**Graymont Western U.S., Inc.**  
**Cricket Mountain Project, Utah**

**Notice of Intention to Revise Mining Operations**  
**Big Sage**

**Re:** Response to Review of Amended Notice of Intention to Commence Large Mining Operations, Graymont Western US, Inc. (Graymont), Big Sage, M/027/006, Task ID# 1826, Millard County, Utah.

**Figure 2. Graymont Western US Inc. Cricket Mountain Project**

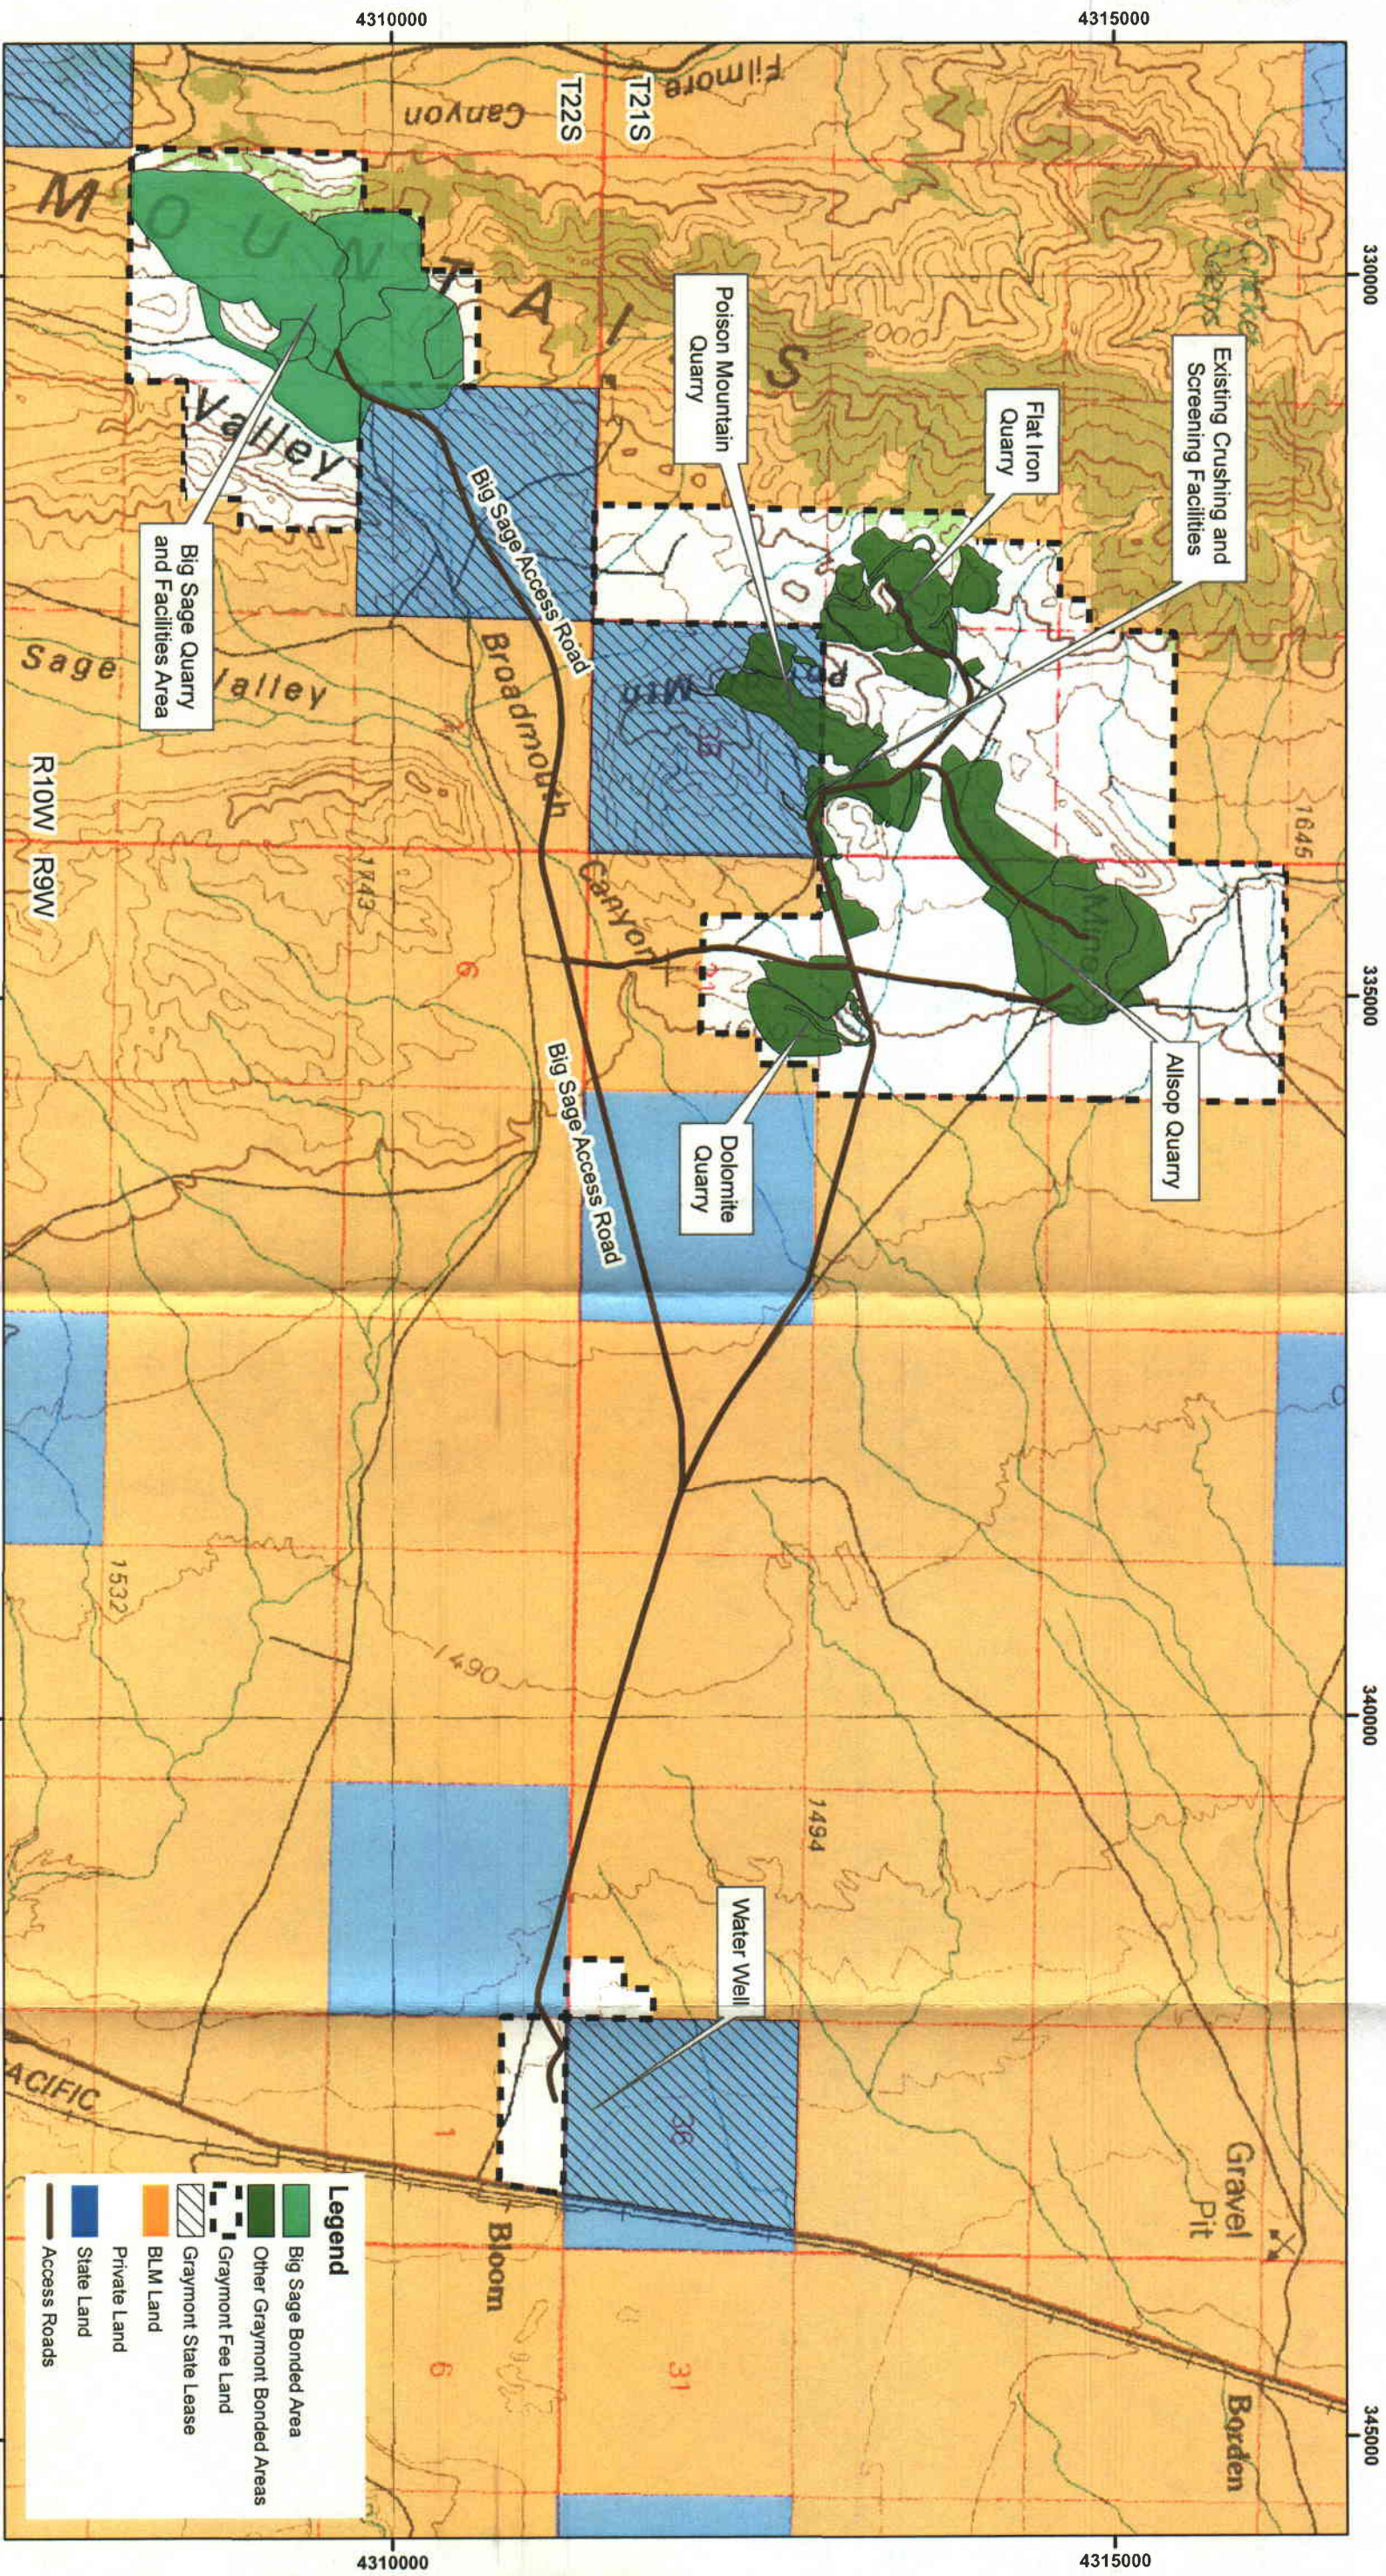
**Figure 2, please label the road called, "The Big Sage Access Road" (BE)**

Figure revised.

Figure 3. Big Sage Quarry Layout

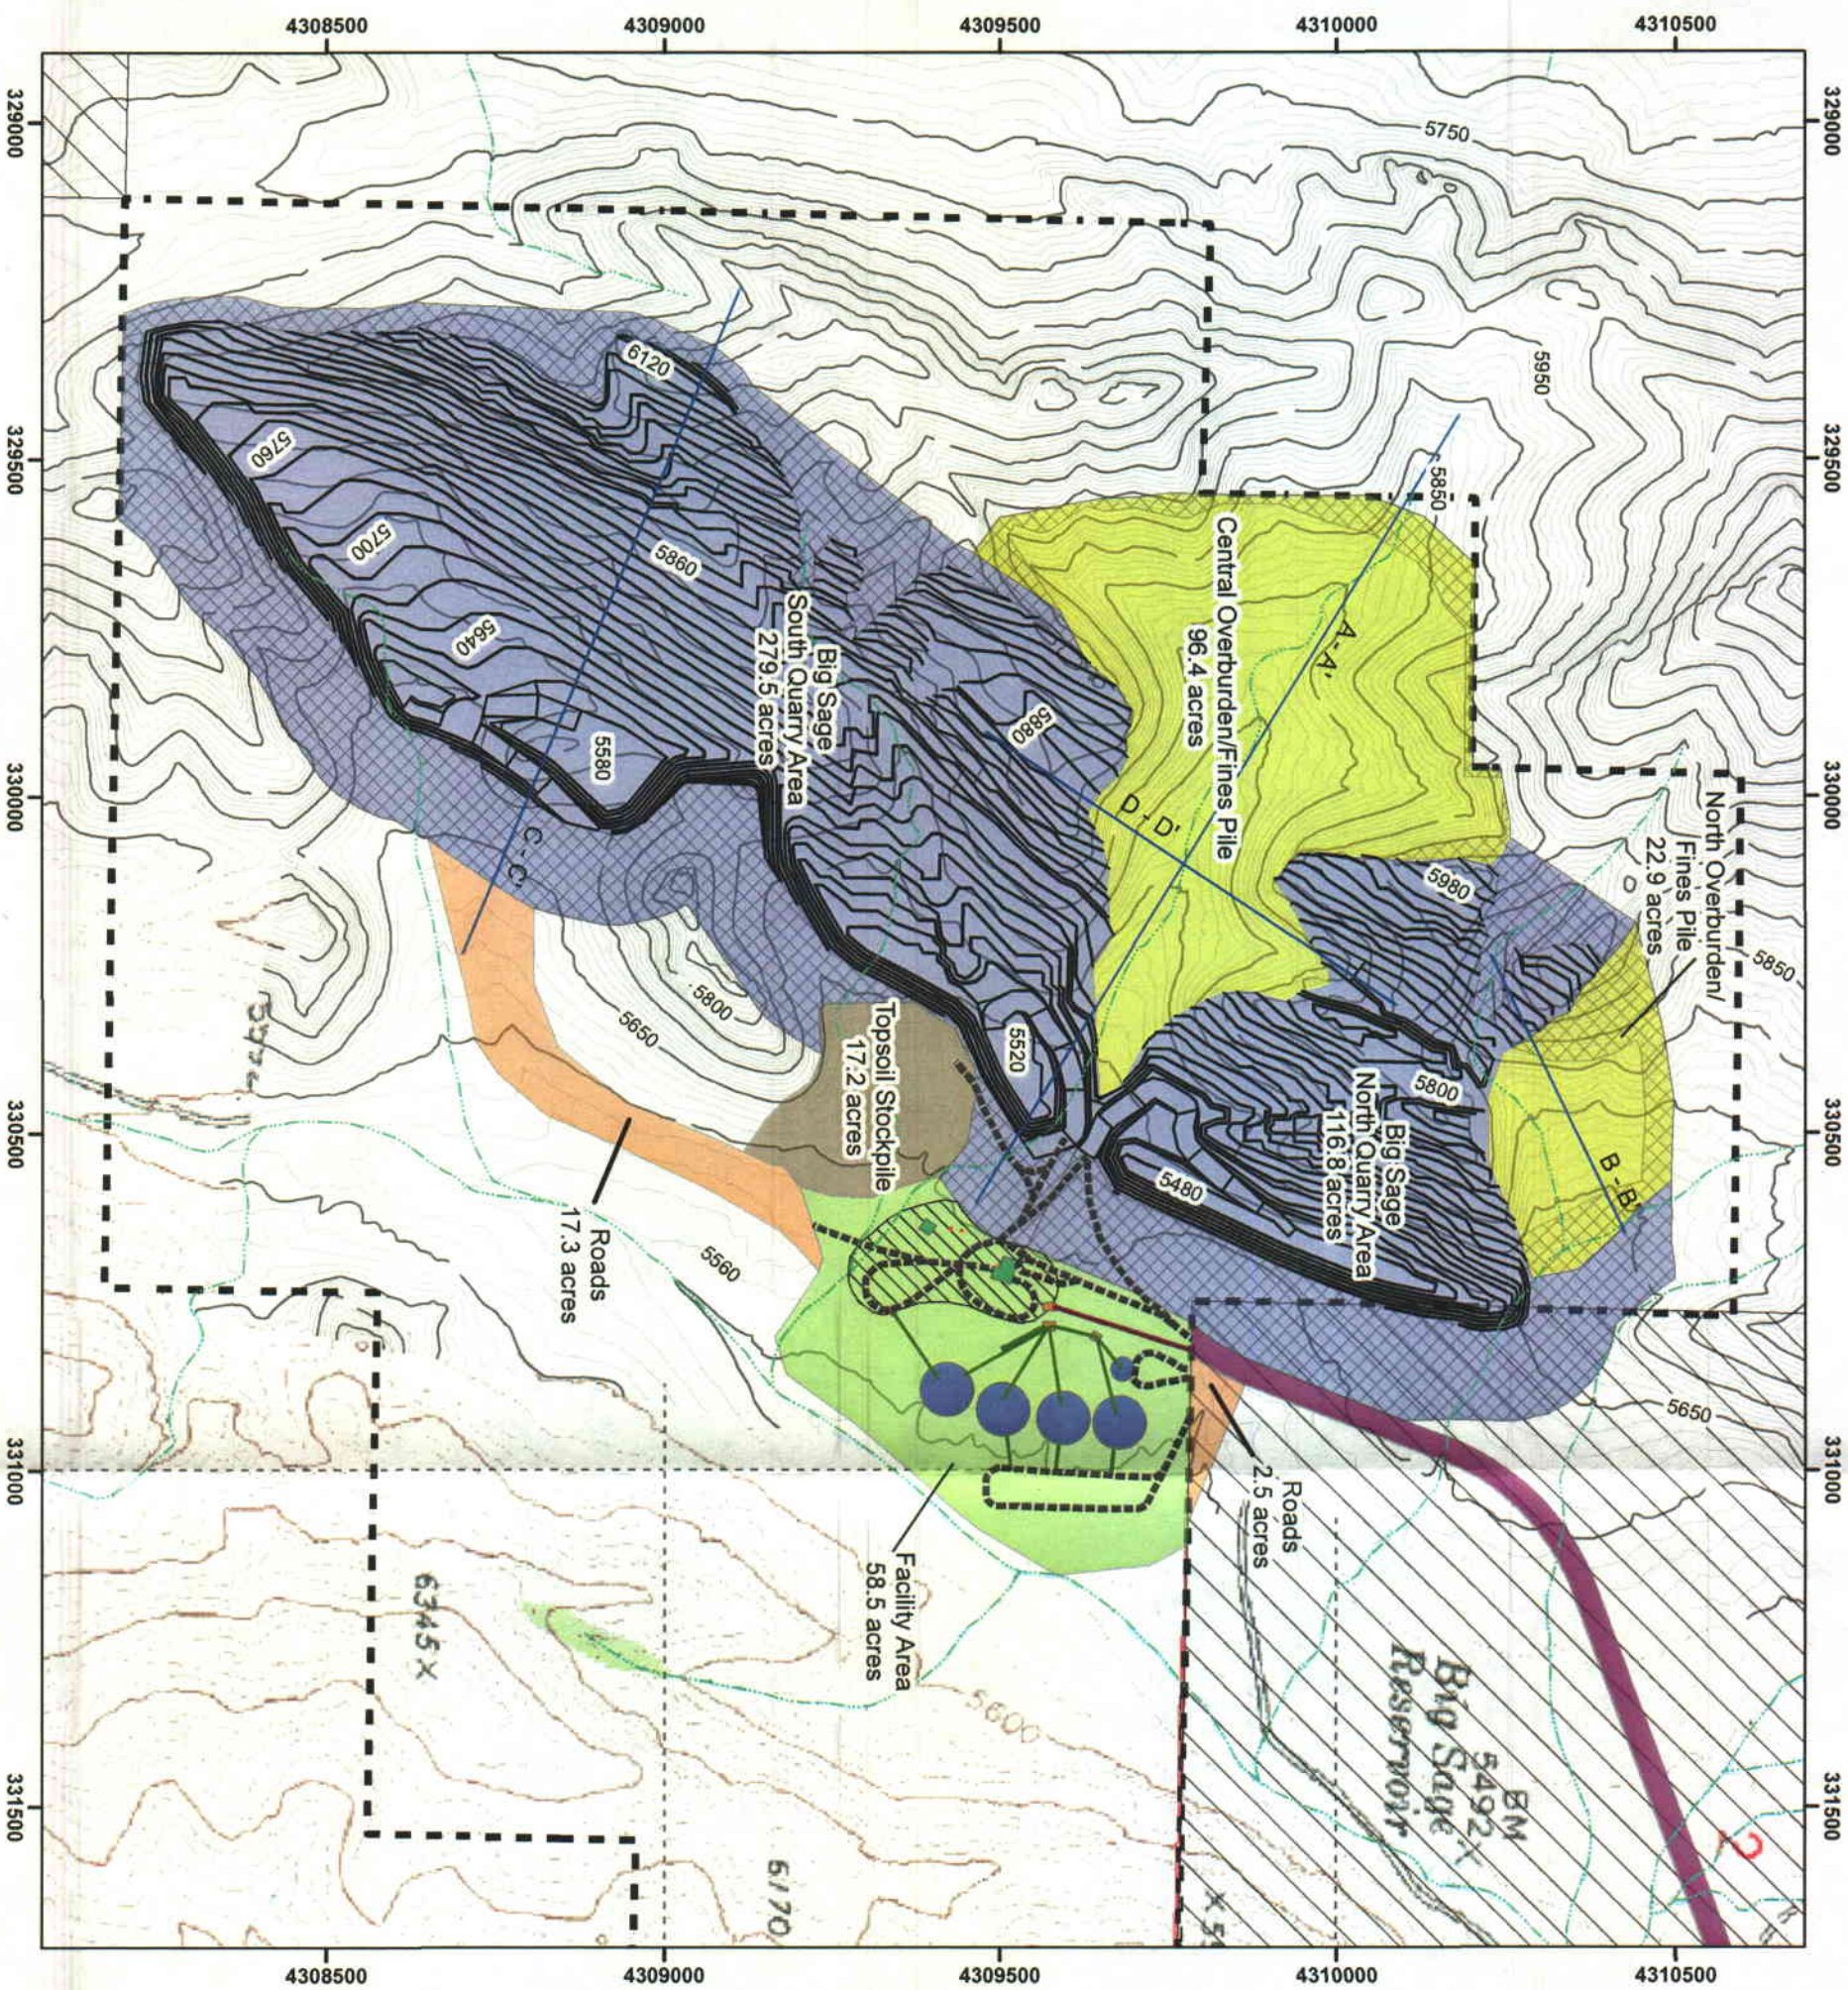
**Figure 3 shows the facility area disturbance as 58.5 acres, but Spreadsheet B indicates 45.6 acres are disturbed. Please ensure consistency, or explain the parameters for determination more clearly. (BE)**

**Figure 3 shows the facility area disturbance as 58.5 acres, but spreadsheet B indicates 45.6 acres are disturbed. Please ensure consistency, or explain the determination parameters more clearly. This comment is a repeat. (BE)**

A narrative is provided to describe the rationale for the surety calculation, and additional notes were added to the spreadsheets to describe where and how reclamation of each component will be conducted. Of the 58.5 acres of disturbance associated with the Facility Area, calculations for reclamation of 10.7 acres associated with interior roads are provided in Spreadsheet D (Haul/Access Roads), and calculations for reclamation of 2.2 acres associated with the stormwater retention pond are provided in Spreadsheet E (Miscellaneous).

**Figure 5. Conceptual Cross-Sections**  
Rev. May 13, 2008  
Graymont Western US Inc.

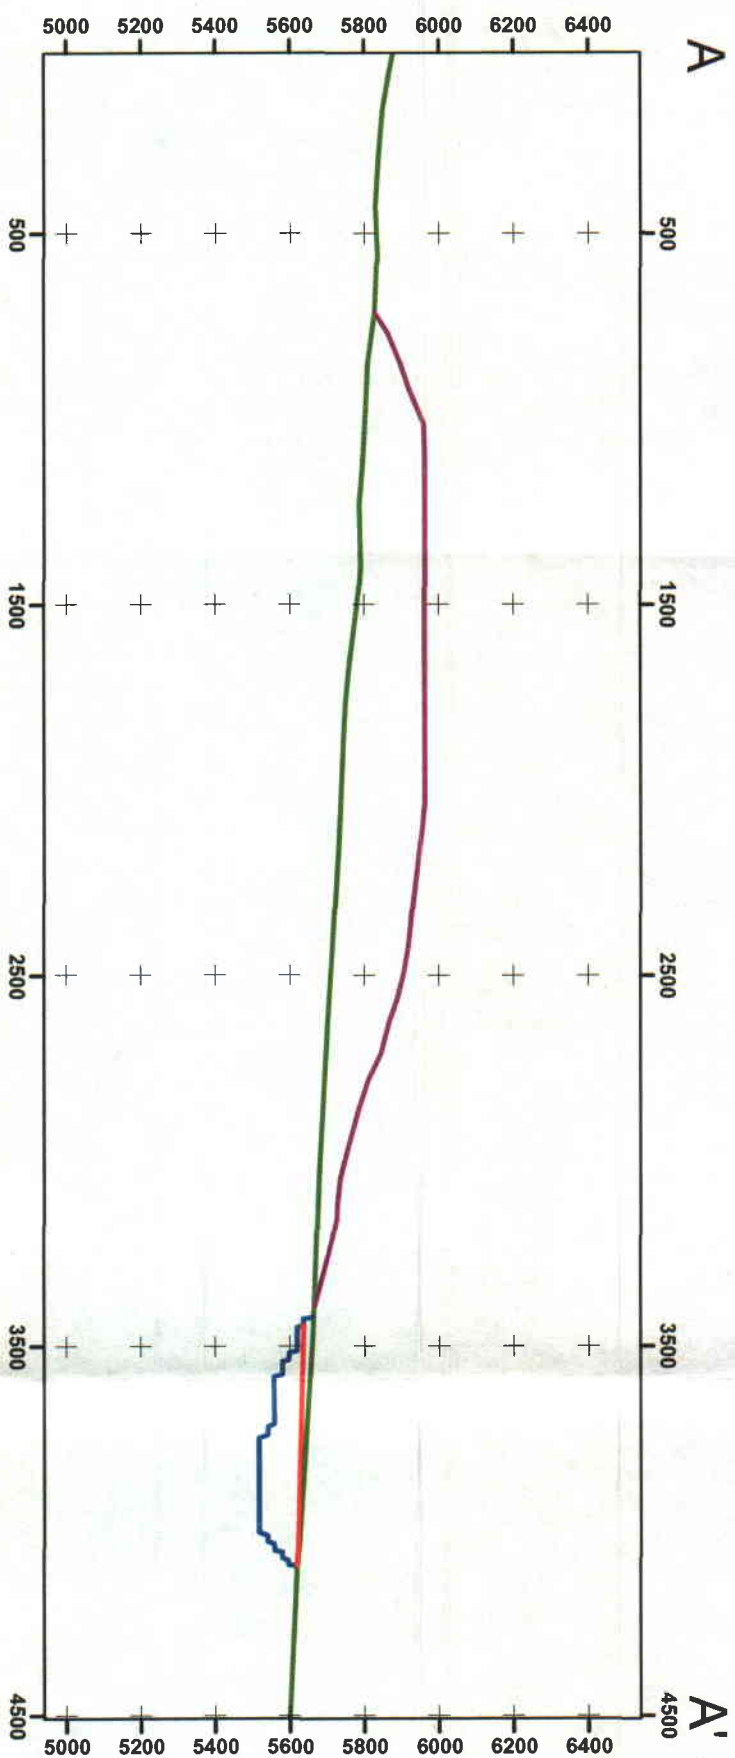
**3.18 Show on Figure 5 (or in a new figure), a geology layer is necessary as there may be a slide potential in the footwall shale layer. (BE)**

Figure 5 has been revised to include an approximate location of the Chisholm Formation and Dome Limestone contact.
